Declaration of differences Aegex10 and Inari10 variant models

Aegex Technologies LLC declare the following variants models:

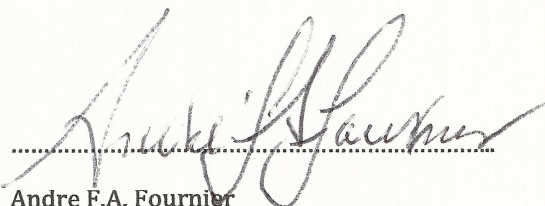
AEGEX10-LTB01 and AEGEX10-WLA01 are electrically identical except for the LTE related parts (FPC's, antennas, antenna cables and Huawei LTE module ME936 as such). FCC ID: 2AGVY-AEGEX10-LTB01 (for model Aegex10 with Huawei LTE module ME936 embedded), and FCC ID: 2AGVY-AEGEX10-WLA01 (for model Aegex10 with WiFi).

The additional design changes between the basic AEGEX10-xxxx and the Inari10-xxx are:

- Resistors were added to some of the signal traces to prevent energy surge
- FET-s were added to some of the power lines to protect against energy surge or short circuit.
- A protective case was added to provide better protection against drops
- Silicone compound was used to encapsulate some of the circuits on the PCB.
